RC250077 Awa Koura Mining Limited – RFI and initial comments on noise effects

This advice focuses on the report prepared by Marshall Day Acoustics entitled “*Sandy Point Alluvial Gold Mine Noise Assessment*”², (the **MDA Report**).

Figure 3: Aerial view of modelling assessed scenarios

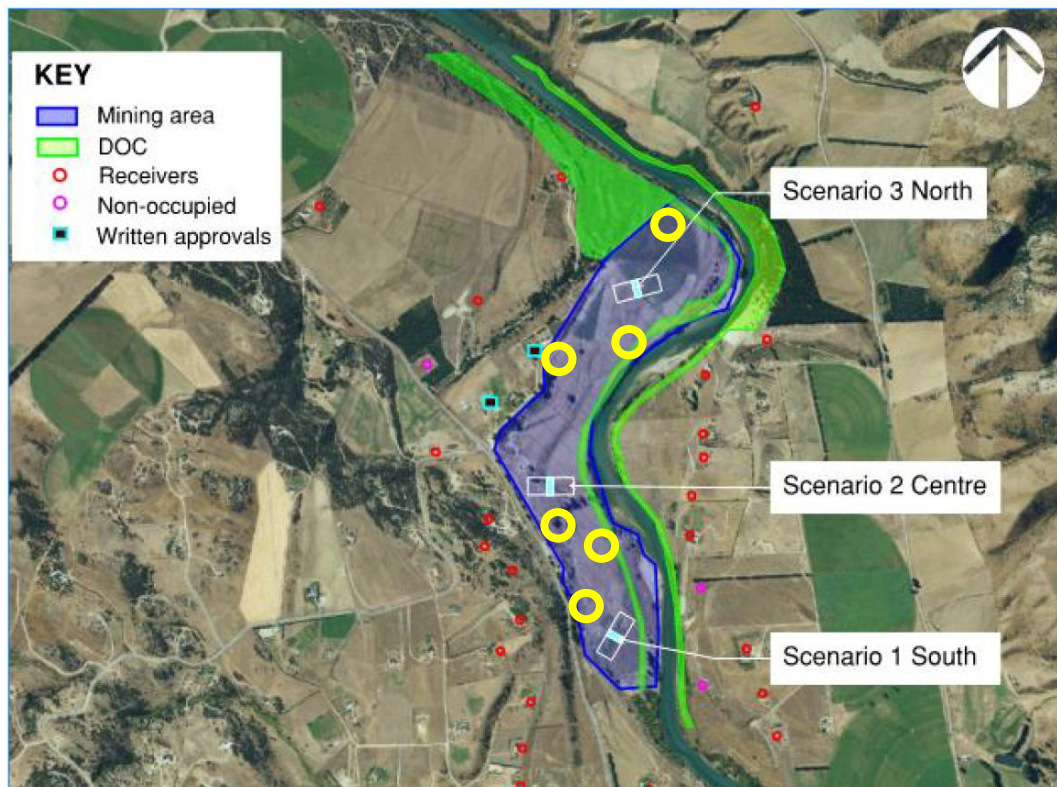
3. *It appears that the MDA report doesn't assess the mining locations closest to some of the houses. I would want to talk this through with MDA, but I expect that there are mining locations that are closer to some of the houses that should be assessed.*

My reading of the Application material is that the excavating and processing plant follow the face of the excavation in a zig-zag pattern across the site. That means that the plant will be concentrated together in small areas across every part of the site over the 3 year period.

In contrast, the MDA Report only assesses the concentration of mining plant at three locations³. These locations have been used to calculate the predicted noise levels in the MDA Report. The predicted noise levels only represent mining in those three locations. I consider that there are many other locations where the plant will be much closer to the neighbouring dwellings than the three locations selected.

I therefore consider that that a number of additional locations need to be considered to robustly demonstrate the predicted noise levels and effects of the proposal.

I recommend that the scenarios in the MDA Report are supplemented with noise level predictions for the scenarios set out below in yellow circles (reproduced Figure 3 of MDA Report).
